NOTICE OF PASSING OF AN OFFICIAL PLAN AMENDMENT
Subsection 17(24) of the Planning Act

Amendment No. 176

PUBLIC MEETING RECOMMENDATION REPORT (WARD 2)

Official Plan and Zoning By-law Amendment applications to permit 180, three storey, back to back townhouses in 12 development blocks

MAP 'A'
 Part of Schedule 10
 Land Use Designations
 of Mississauga Official Plan

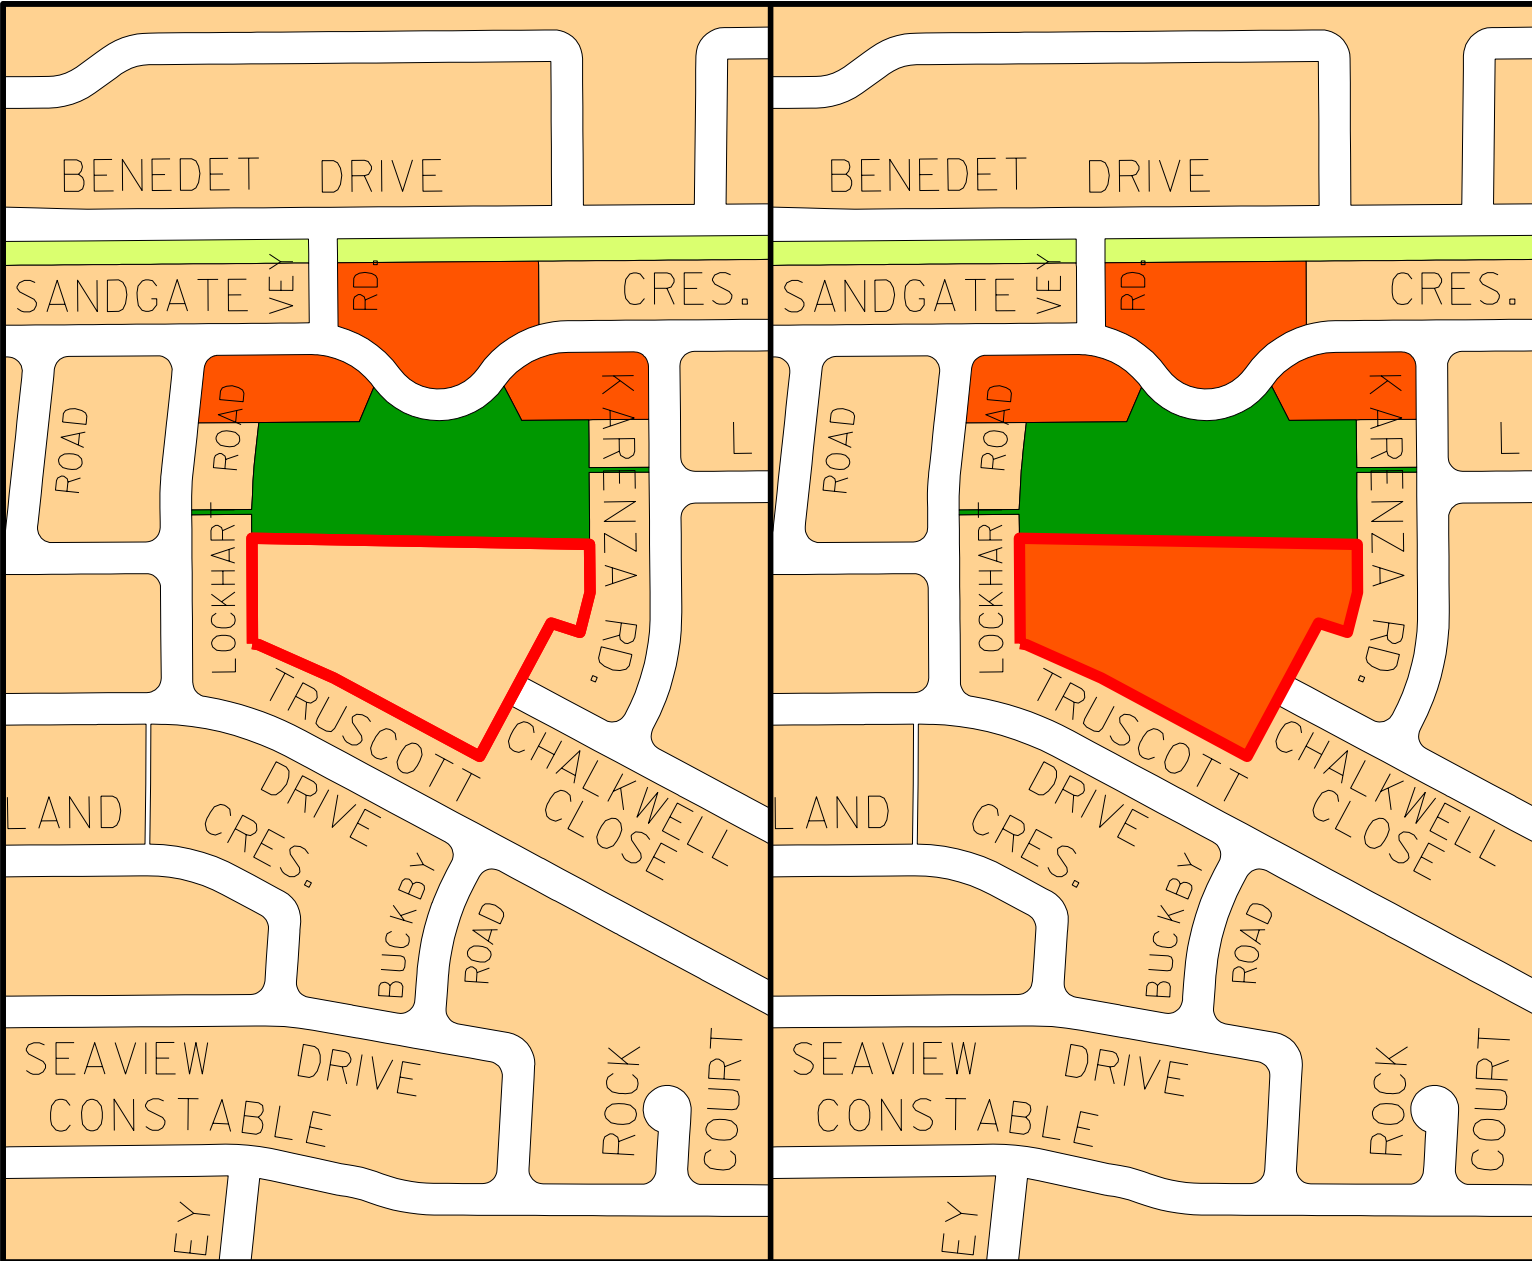
1. Schedule 10, Land Use Designations, of Mississauga Official Plan, is hereby amended by changing the land use designation of the subject lands from Residential Low Density II to Residential Medium Density, as shown on Map "A" of this Amendment.

Figure 5: Deployment of a 45-degree angular plane line marked in red to demonstrate the scale of massing for proposed Townhouse Blocks F and L in relation to proposed setbacks to existing residential rear yards.

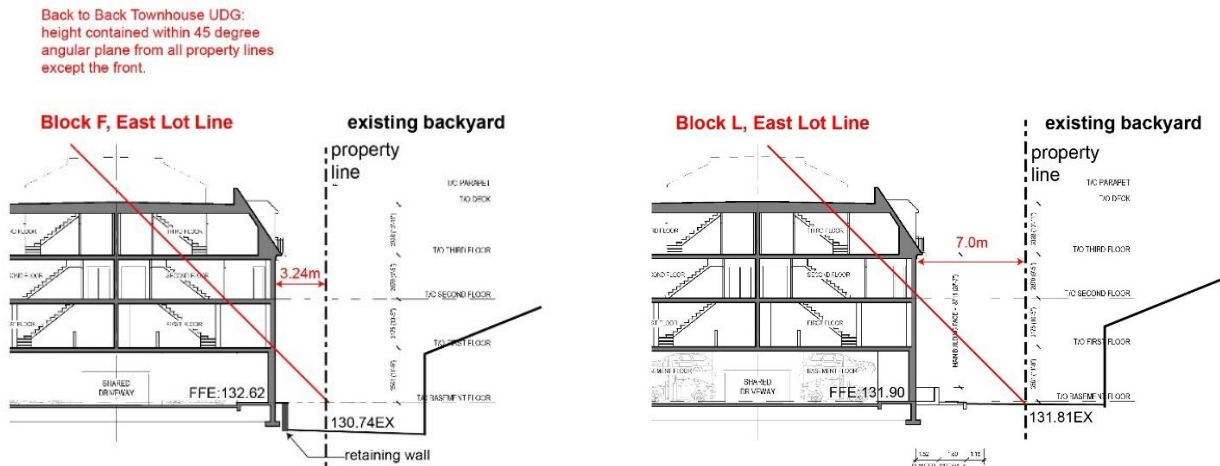
Without the implementation of building setbacks on the top floor of the townhouses, the proposed reductions to landscape buffers and building setbacks, the proposed development does not consider the scale of the townhouse blocks to the surrounding context.

2. Concept Plan, Elevations, Renderings

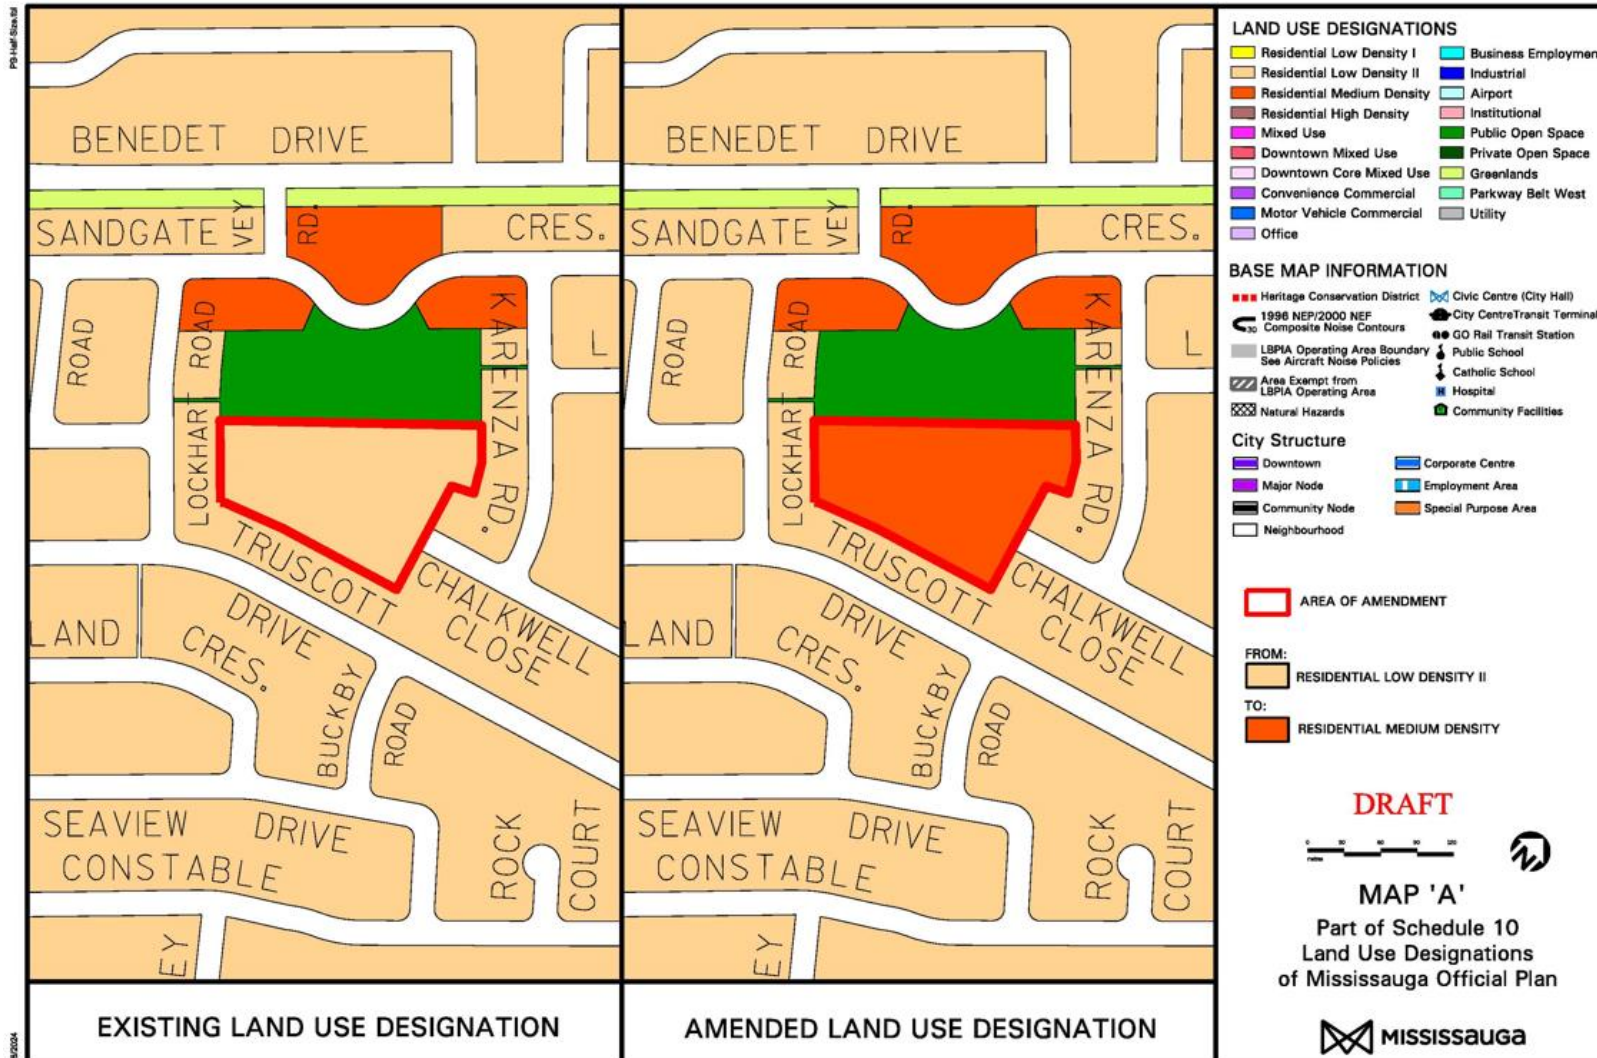
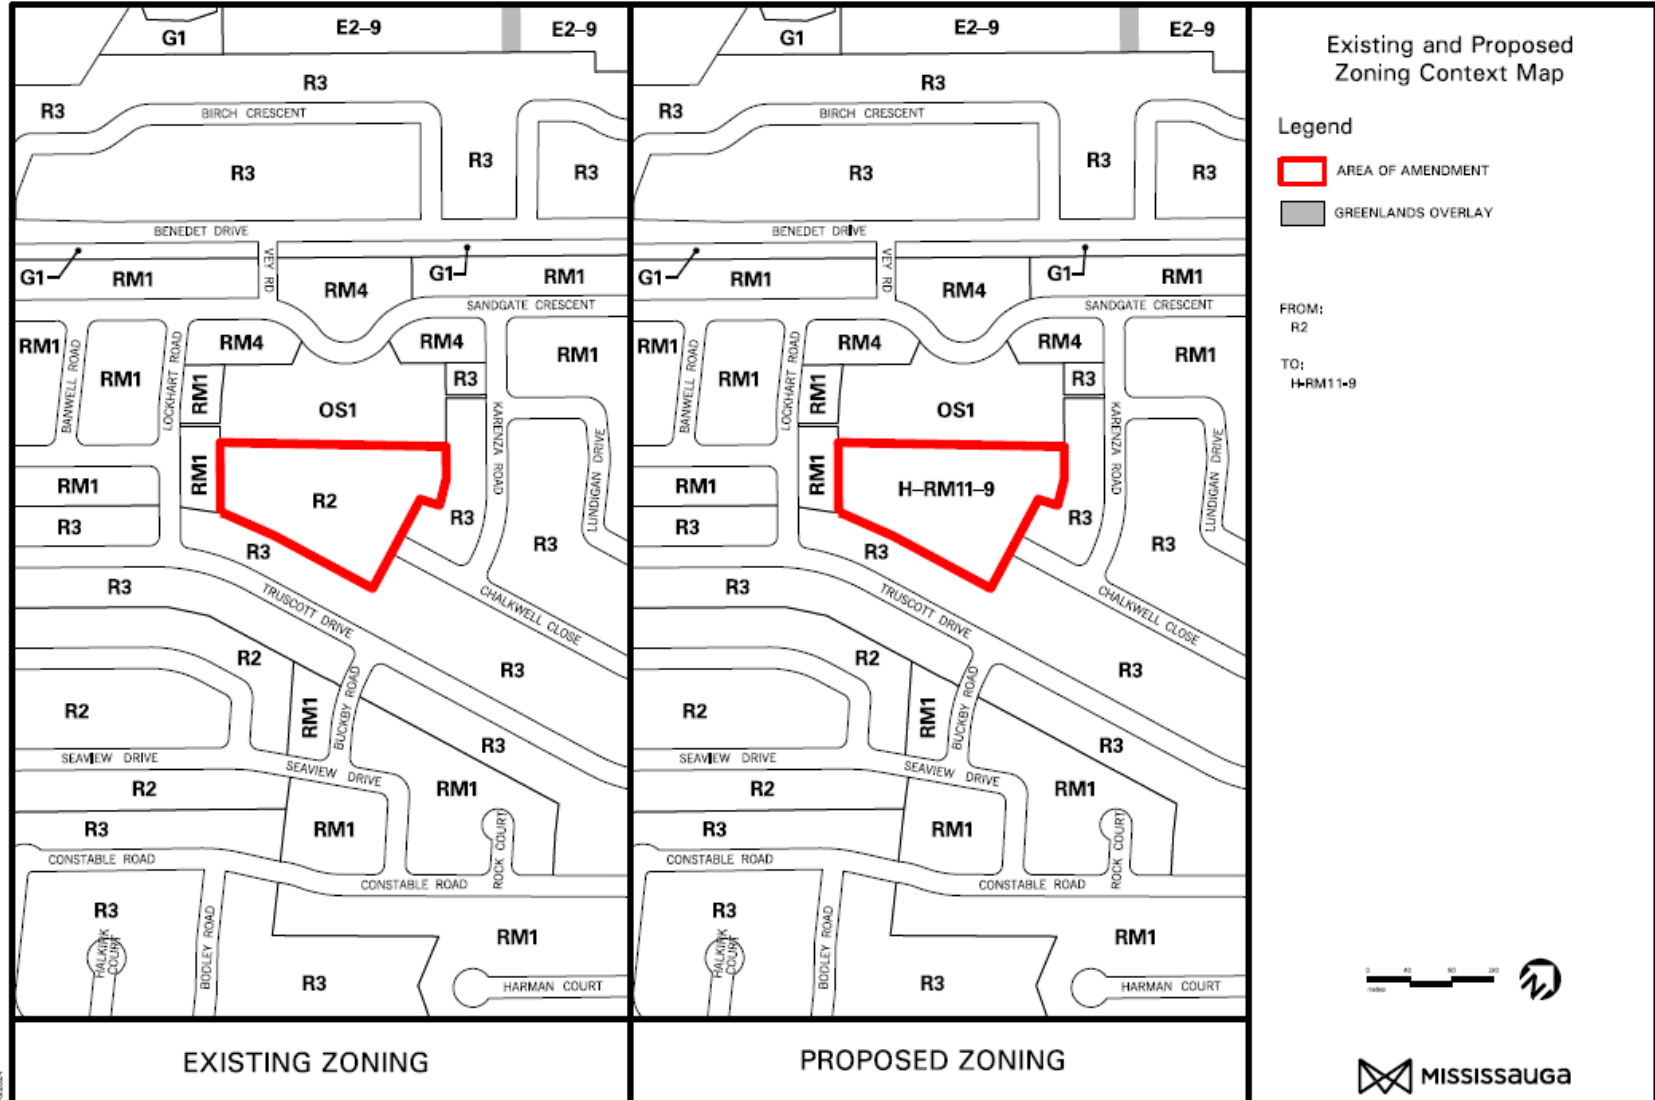
- Omitted information on the concept plan including: transformer locations, community mailboxes, light poles, fire hydrants and sufficient waste collection locations;

- Waste collection plan that is inconsistent with Region of Peel standards;
- Obstructed fire access route for Blocks A, B, C, D, E, F G, and H and inappropriate turning locations for fire and emergency vehicles throughout the site;

Agency / Comment Date	Comments
	<ul style="list-style-type: none"> • Road network with dead ends and fire access route exceeding 90 metres without sufficient turnaround. • Additional information regarding car stackers and mechanism for residential parking spaces. • Minimum 1 metre setback required for rooftop access for townhouses abutting detached and semi-detached dwellings. • Double fence condition for retaining wall along easterly property line. • Interconnections proposed between townhouse blocks on main floor plan. • Incomplete Sun/Shadow Study. • Review of rooftop terrace in Noise (Acoustical Feasibility) Study. • Encumbered landscape buffers and amenity spaces. • Stormwater management tank proposed in conflict with proposed tree planting. • Coordination of all drawings/plans required. • Label and dimension all landscaped buffers and existing easement. • Incomplete arborist report and inconsistencies between site plan and tree preservation plan.
